Meeting: Date:	Traffic Management Meeting 26 January 2011		
Subject:	Proposed build-out and flat-topped road hump, Appenine Way, Leighton Buzzard		
Report of:	Basil Jackson Assistant Director for Highways and Transportation		
Summary:	To report to the Portfolio Holder for Safer Communities and Healthier Lifestyles the receipt of objections to a proposal to install a build-out and flat-topped road hump on Appenine Way, Leighton Buzzard.		
Contact Office	r: Amanda Tarbox, Assistant Engineer amanda.tarbox@amey.co.uk

That the proposal to install a build out and flat-topped road hump on Appenine Way, Leighton Buzzard be implemented as advertised.

Appendix A

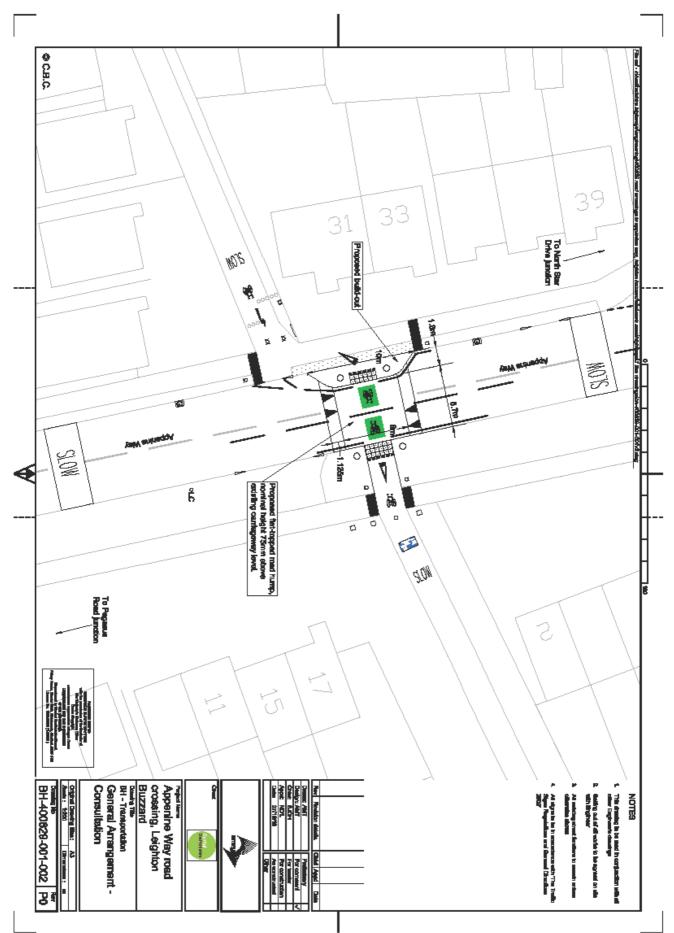
The Objection I have with the proposed plans are the issues it was cause us with Lack of parking and access to our house.

Where your Plans are for and that is right out the front of my house and where me or My wife Park, and most the people who live in our row of houses.

My first concern is that no consideration has been taken whatsoever for the impact this work would have to us as homeowners - we will lose all our parking to the front and have the inconvenience of the traffic, the noise and the congestion right outside our property yet 100 yards to the right of us or two hundred yards to the left of us you would be able to build the ramp and it would not affect any home owners whatsoever.

I am concerned that it has not been noted that the spot you feel is suitable for the hump is not suitable at all in fact it is a blind spot.

The main reason for my objection is the reduction in parking spaces that this proposed scheme will cause. This section of Appenine Way has more houses fronting the road and therefore has cars parked on the road in front of the houses because the houses do not have driveways, and I believe the installation of this road hump will reduce the parking spaces by about 3, thus resulting in more congestion which in turn could cause more hazards to pedestrians and cyclists.

The proposed build-out measures 10 metres in length – this would displace two vehicles. Although there is a relatively high demand for on-street parking in this area, there should be space to accommodate these displaced vehicles on-street although not directly outside of their property.

The build-out has been designed to be 1.8 metres wide – this is approximately the same width as a car, leaving a remaining carriageway width of 5.7 metres. This is a sufficient carriageway width for two cars to pass one another so should not make any difference to the existing levels of noise and congestion as often vehicles are parked here.

The proposed build-out and flat-topped road hump has been designed as a crossing point for pedestrians and cyclists to use and has been situated at this location to join the two footpaths that run east to west through the estate.

The existing dropped kerb at this location has reduced visibility due to parked vehicles either side; the aim of the scheme is to improve road safety for pedestrians and cyclists wanting to cross the road at this location, particularly children attending local schools.

The section of Appenine Way where the proposed build-out and flat-topped road hump is to be located is relatively straight with good visibility; however vehicles parked along this section do reduce the visibility for vehicles at the junction with North Star Drive and for pedestrians and cyclists crossing the road.

The preliminary aim of this scheme is to improve the crossing facilities for pedestrians and cyclists crossing Appenine Way at this point; other forms of traffic calming such as speed cushions would not serve this purpose; if a road hump was installed without a build-out it would be likely to be parked across.
